NOTICE TO ALL FIRMS

Re: Addendum Number 2
IFB # C1762 – Science Department Renovation

FIT Science Lab Renovation

AUDIOVISUAL SYSTEMS BID ADDENDUM #2

3RD FLOOR ELECTRICAL POWER PLAN

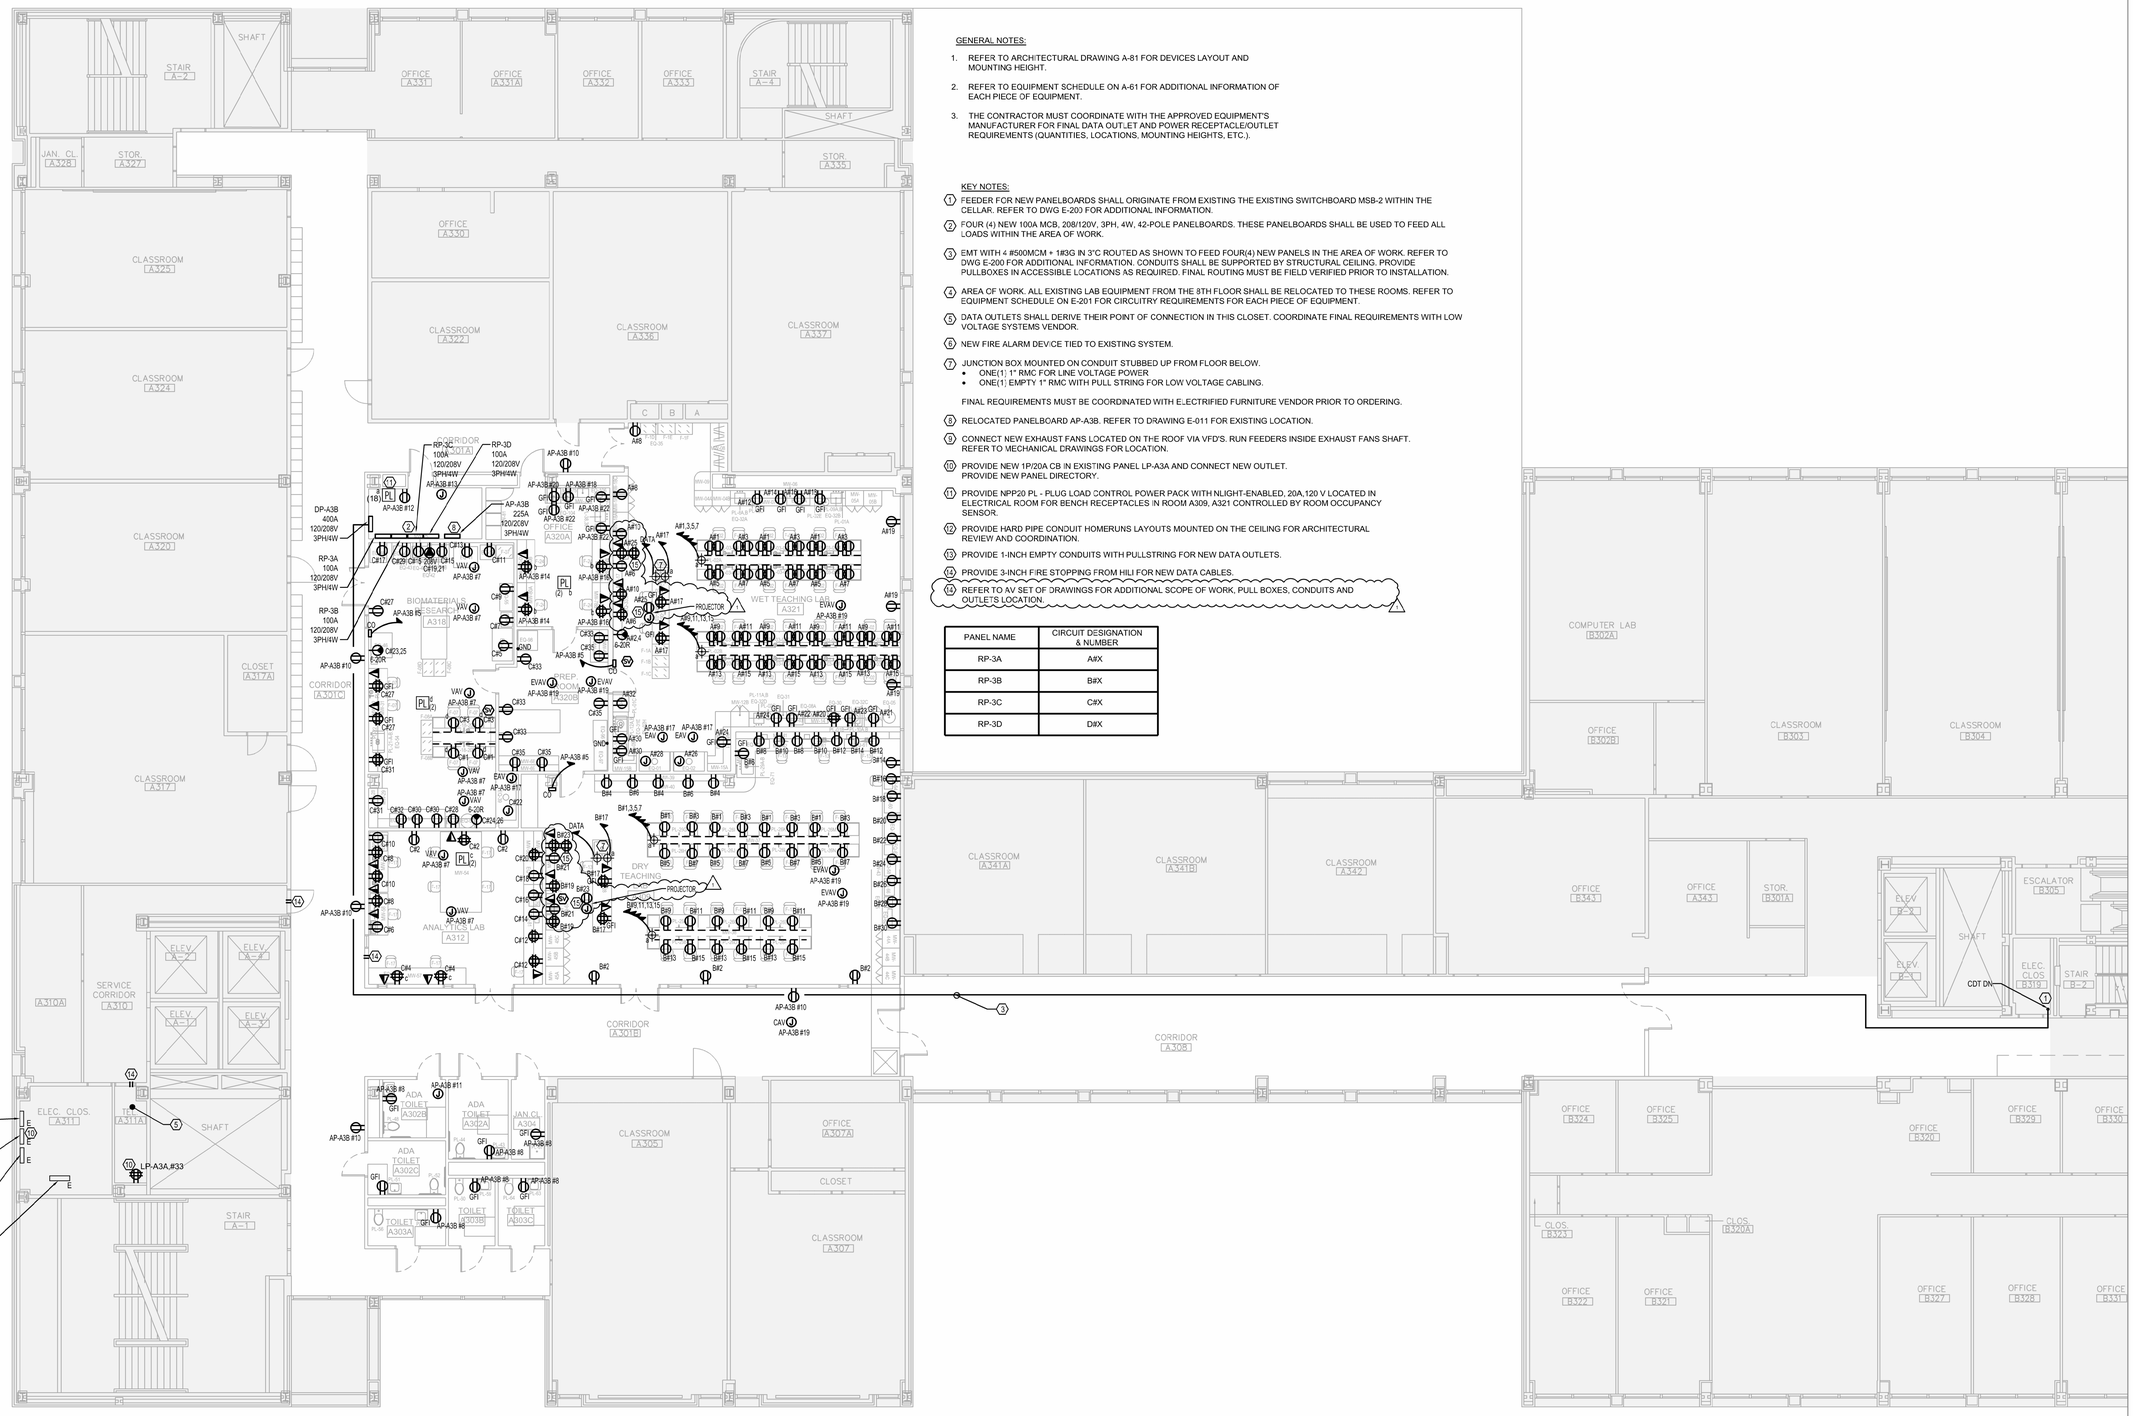
See Electrical and AV Drawings attached.

No.	DESCRIPTION	DATE
	100% DESIGN DEVELOPMENT	2026.03.31
	100% CONSTRUCTION DOCUMENT	2026.08.19
	ISSUED FOR DOB FILING	2026.10.21
	100% BID DOCUMENTS	2026.10.28
△	BID ADDENDUM #2	2026.11.17

1 AV PLAN — DRY TEACHING LAB A309

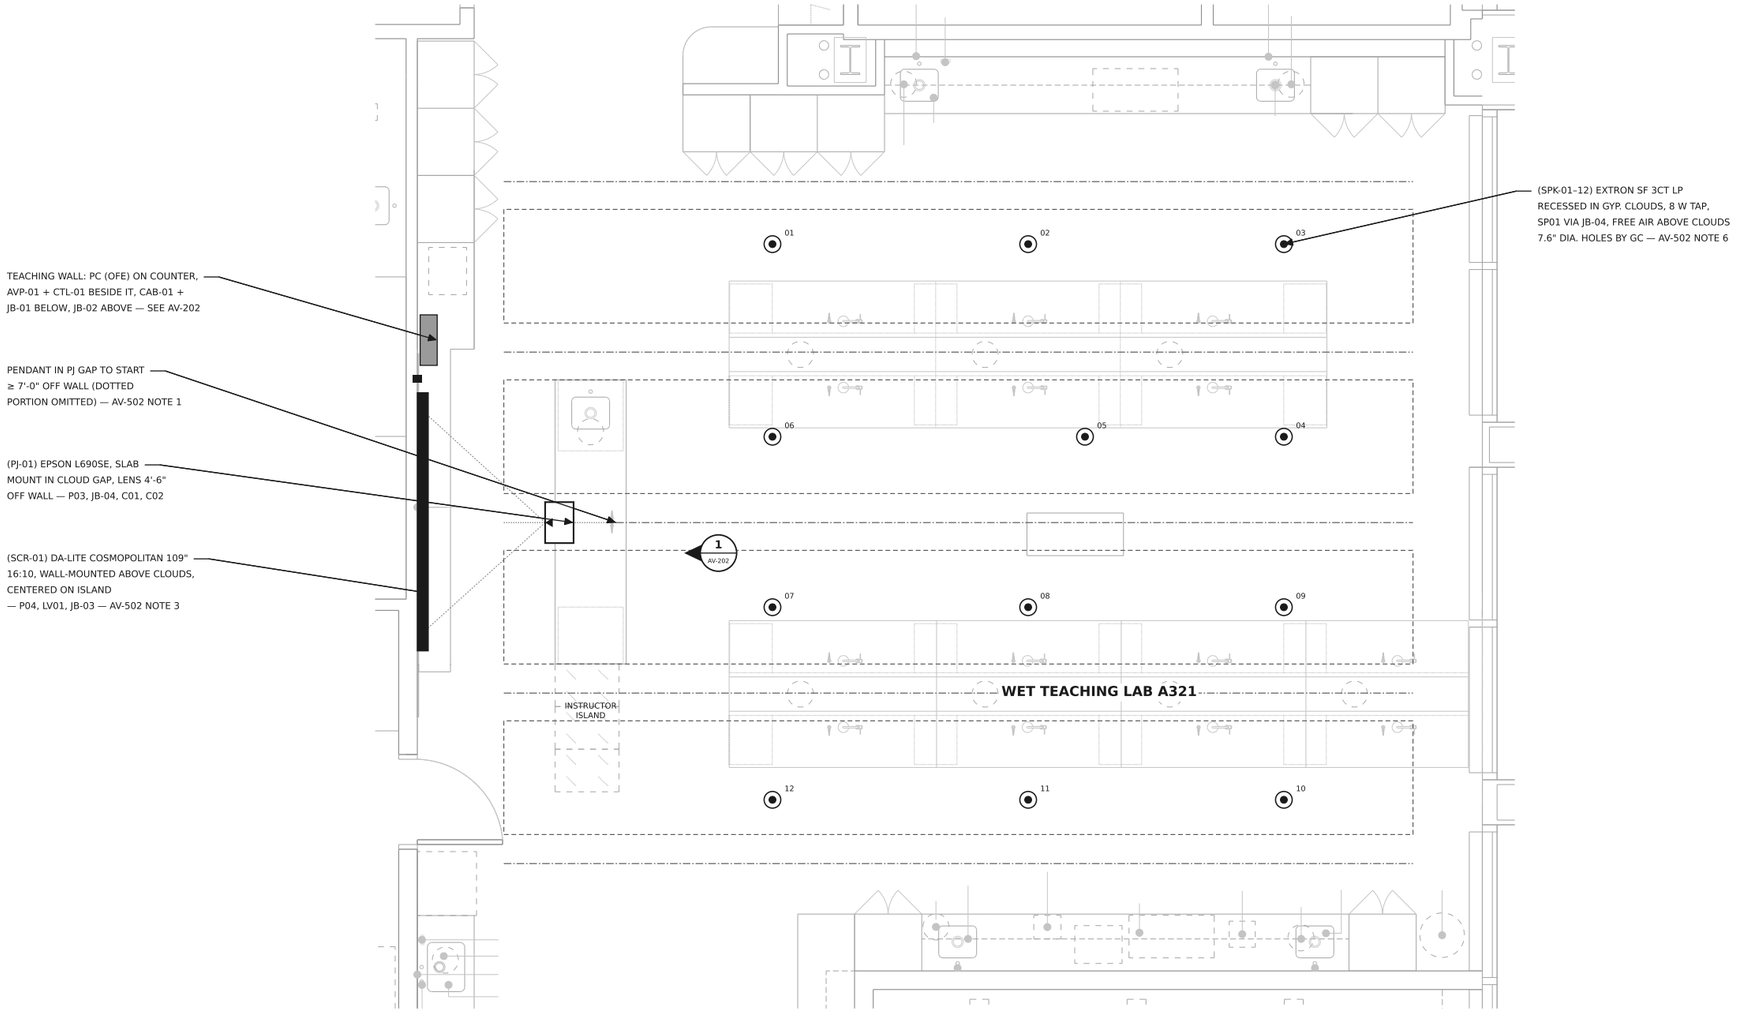
1. Projector PJ-01 hangs in the 2-ft gap between clouds on the island centerline. Start the A-11 pendant fixture in this gap ≥ 7'-0" off the board wall so PJ-01 and its mount clear it. [Architect / EC]

2. Delete the projector placeholder: A-11 "PJ" and the E-201 "PROJECTOR" receptacle + data at ≈9' off the board wall. PJ-01 power and cabling are at P03 / JB-04, ≈5' off the wall. [EC]

3. GC to install SCR-01 (Da-Lite Cosmopolitan Electrol 109", furnished by FIT's AV Contractor) on the board wall above the 7'-8" cloud plane, case ≈8'-1"–8'-7" AFF. Include blocking in the wall to mount the screen housing over its ≈9'-1" length. Keep ductwork clear of the wall to ≈8'-8" over the case length (A-21 duct bottom ≈9'-0" (ducts 9'-3")). EC provides P04 at the north (motor) end. [GC / MEP / EC]

1 AV PLAN — WET TEACHING LAB A321

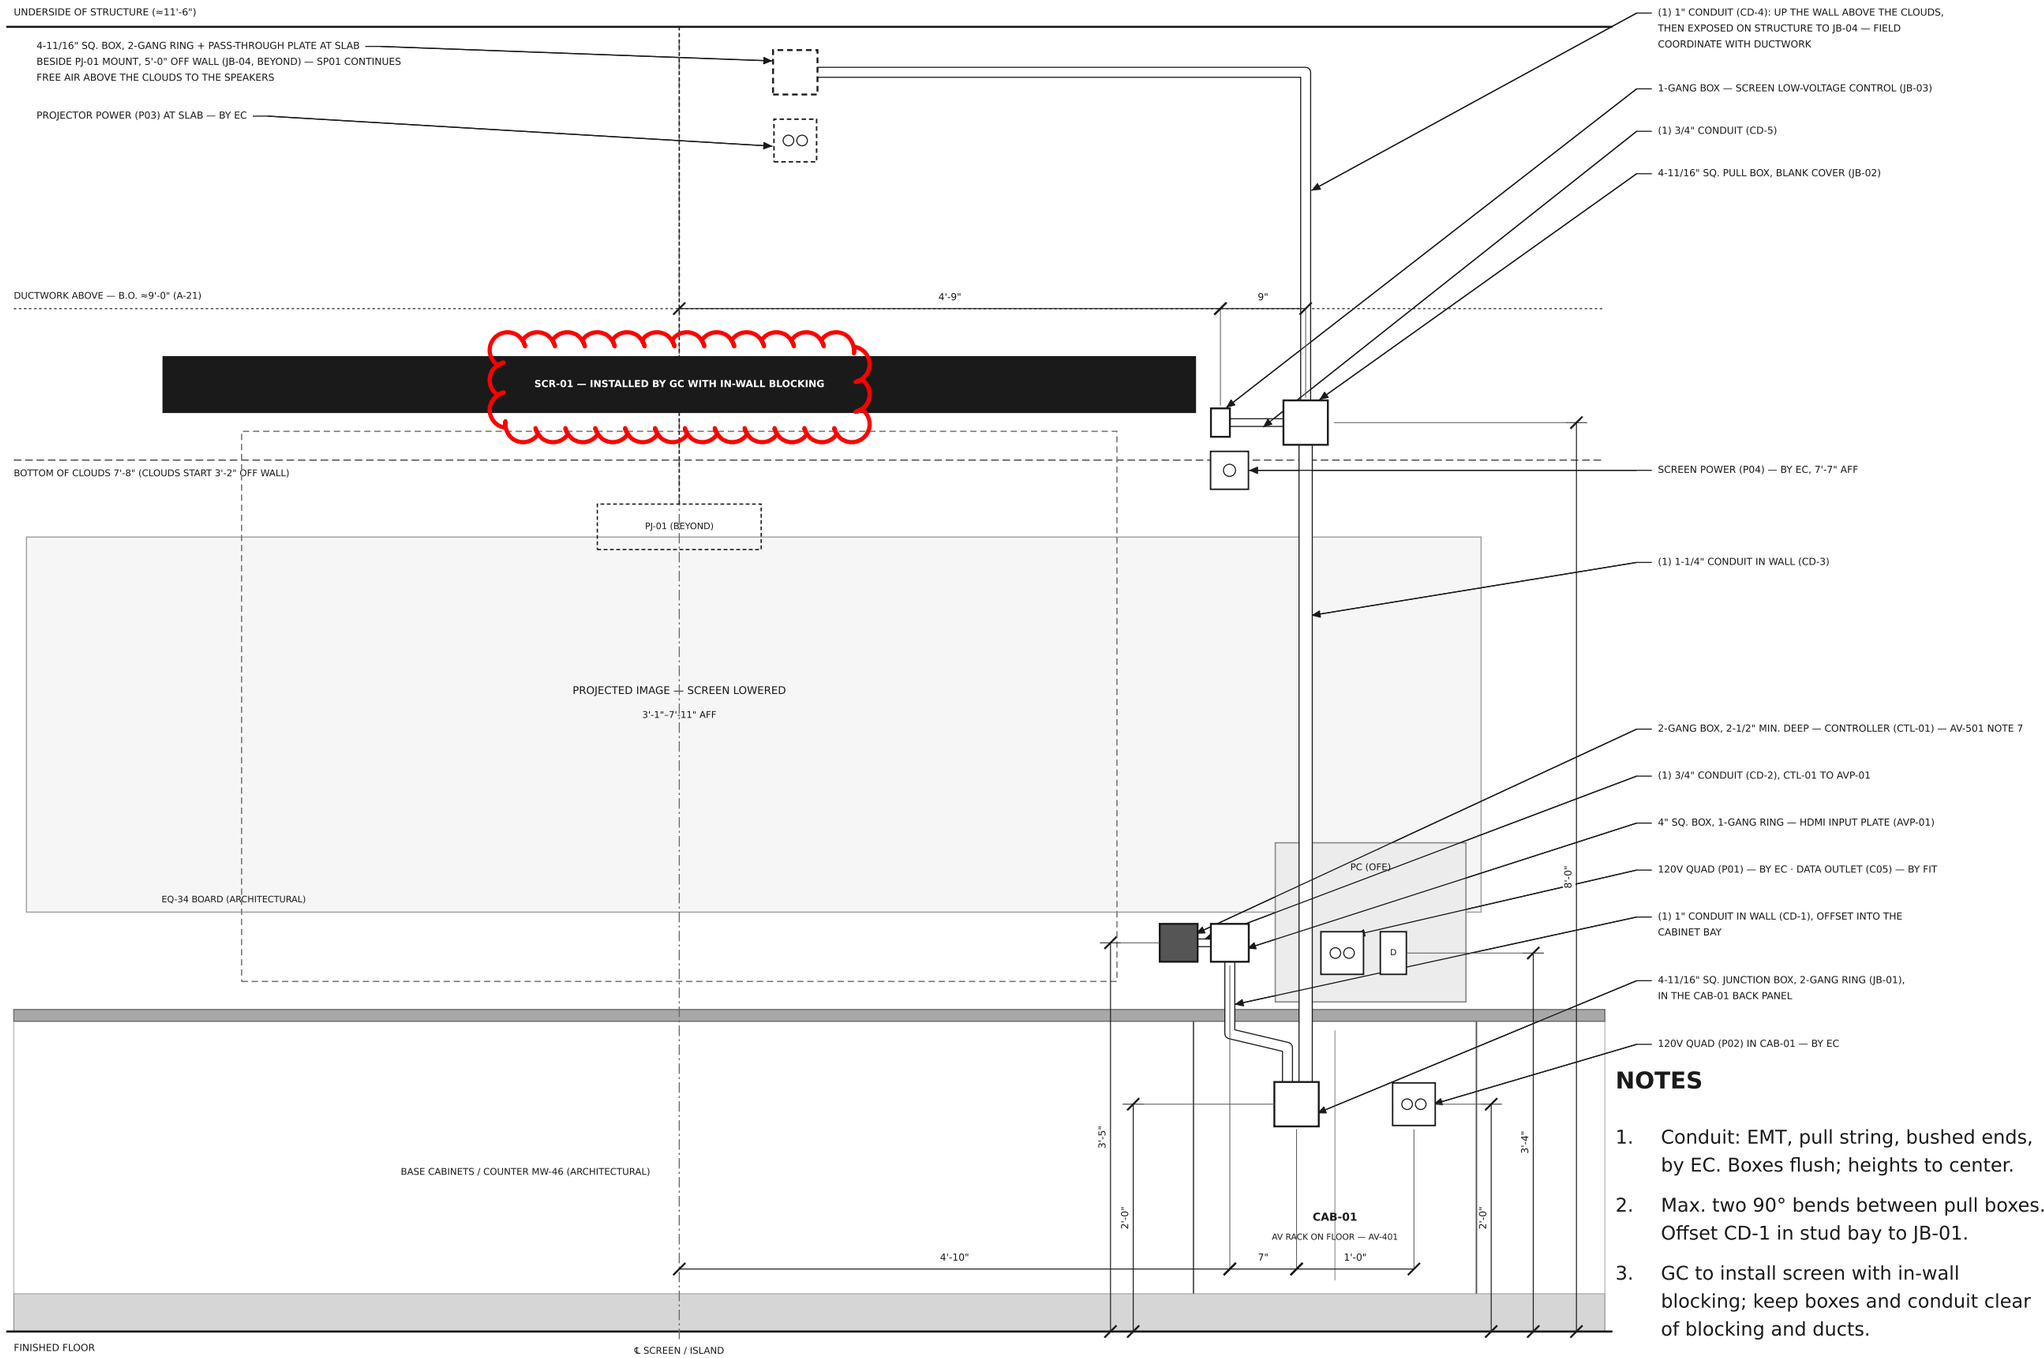
1. Projector PJ-01 hangs in the 2-ft gap between clouds on the island centerline. Start the A-11 pendant fixture in this gap ≥ 7'-0" off the board wall so PJ-01 and its mount clear it. [Architect / EC]

2. Delete the projector placeholder: A-11 "PJ" and the E-201 "PROJECTOR" receptacle + data at ≈9' off the board wall. PJ-01 power and cabling are at P03 / JB-04, ≈5' off the wall. [EC]

3. GC to install SCR-01 (Da-Lite Cosmopolitan Electrol 109", furnished by FIT's AV Contractor) on the board wall above the 8'-0" cloud plane, case ≈8'-1"–8'-7" AFF. Include blocking in the wall to mount the screen housing over its ≈9'-1" length. Keep ductwork clear of the wall to ≈8'-8" over the case length (A-21 duct bottom ≈8'-8¾"). EC provides P04 at the north (motor) end. [GC / MEP / EC]
